Master Plan Amendment #2019-0002

Development Special Use Permit #2018-0028

Eisenhower East Small Area Plan Amendment and WMATA Office Building – Block 15A

Application	General Data	
Project Name: WMATA Office Building – Block 15A	PC Hearing:	June 25, 2019
	CC Hearing:	July 9, 2019
	If approved, DSUP Expiration:	July 9, 2022 (three years)
	If approved, CDD Expiration:	July 9, 2034 (15 years)
	Plan Acreage:	3.13 acres (136,362 SF)
Location: 2393, 2395, 2403, 2415, and 2421 Mill Road	Existing Zone:	OCM(100) / Office Commercial Medium and UT / Utility and Transportation
	Proposed Zone:	CDD #2 / Coordinated Development District #2 and UT / Utility and Transportation
	Proposed Use:	Office Building with above-ground parking
	Gross / Net Floor Area:	425,187 SF / 408,767 SF
Applicant: Washington Metropolitan Area Transit Authority by Jonathan P. Rak, McGuireWoods, LLP	Small Area Plan:	Eisenhower East
	Historic District:	Not applicable
	Green Building:	LEED Silver or equivalent for non-residential

ATTACHMENT #1: Public Access Easement Area for Open Space Contribution

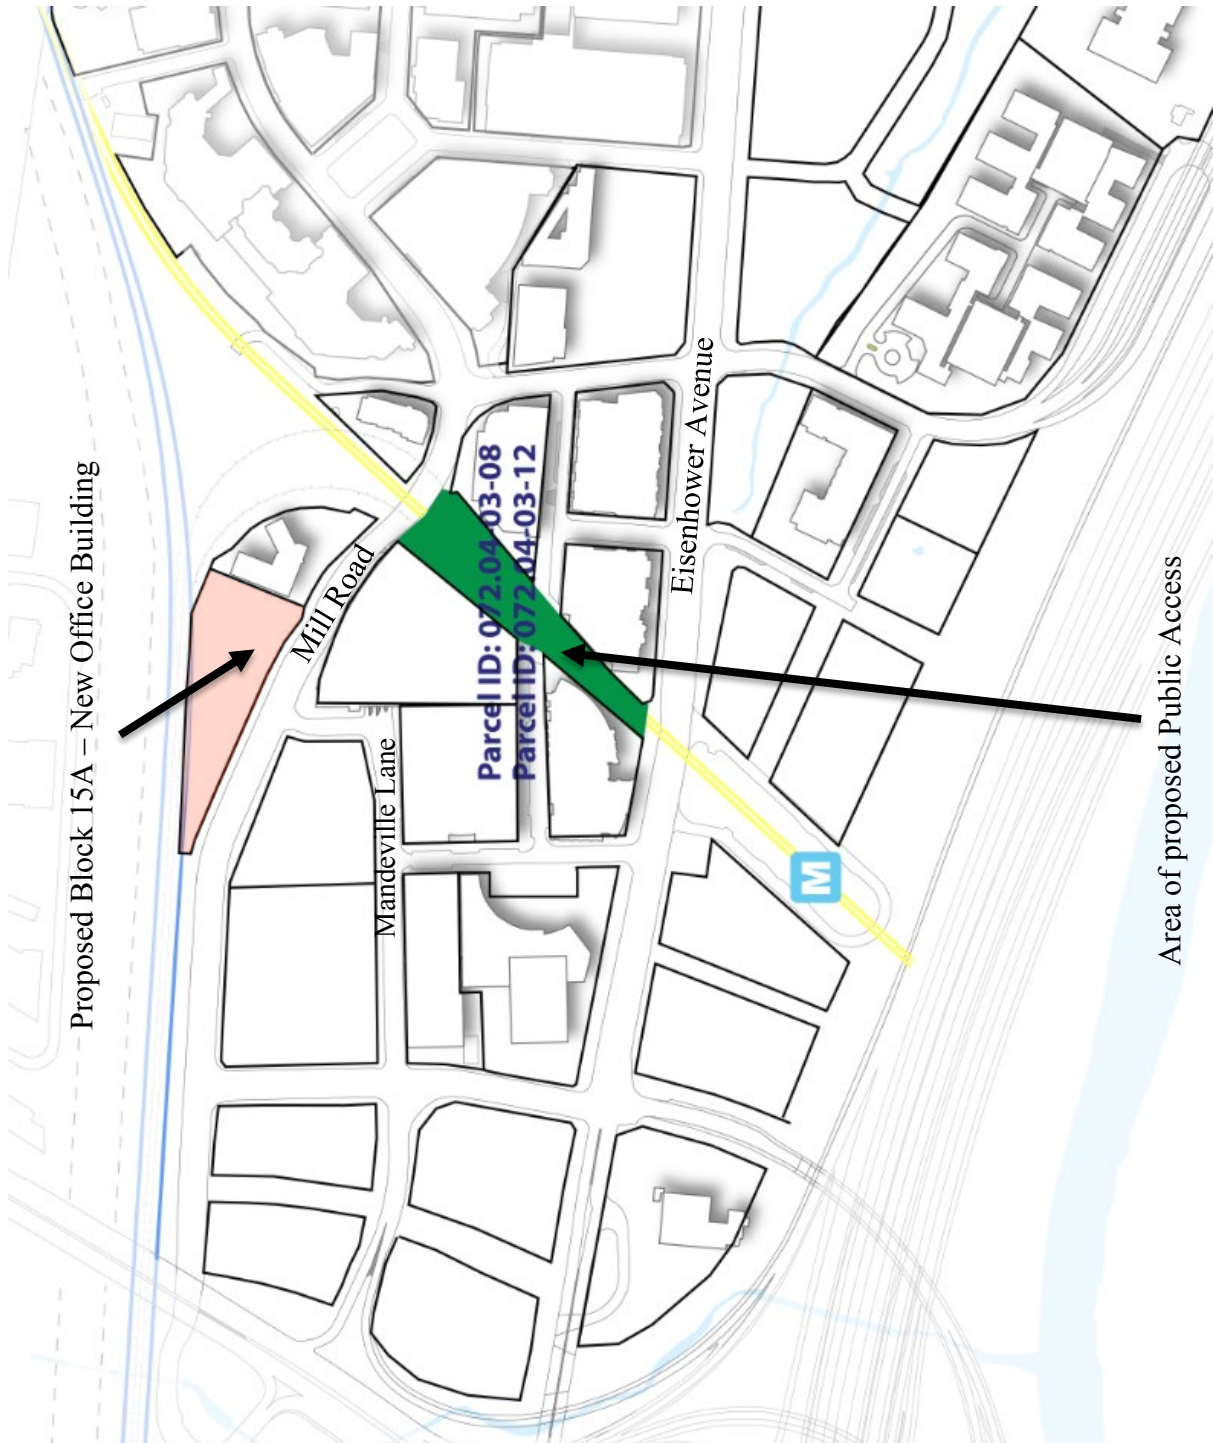
As previously mentioned, a condition has been recommended as part of the CDD #2 amendments that the applicant provide a public access easement for land area owned by WMATA (CDD Condition #145). This area consists of two parcels (Parcel ID 072.04-03-08 and 072.04-03-12) that are located under the Metrorail Yellow Line tracks between Mill Road and Eisenhower Avenue (see Attachment #1). Per the EESAP, all new development within CDD #2 is required to participate in a program for the equitable distribution of costs associated with the implementation of, among other things, open space, which are improvements necessary to support development in the Eisenhower East area. The proposed public access would allow for the activation of underutilized space for passive and/or active open space, entertainment and/or comparable uses for the public. The City will work with WMATA to design this area for public use in compliance with their standards and requirements, while also providing amenities that will benefit the general public. This is consistent with the direction for open space addressed in the EESAP update to be heard this fall.

CONDITION AMENDED BY PLANNING COMMISSION: The applicant will provide public access for open space purposes on parcels identified as 072.04-03-08 and 072.04-03-12. The public access will be provided ~~as an easement or other comparable form of public access~~ through an agreement with the City consistent with Federal regulations, including but not limited to FTA Circular 5010.1I, to be mutually agreed upon by the City and WMATA and will be approved and provided prior to the release of certificate of occupancy permit for the office building.
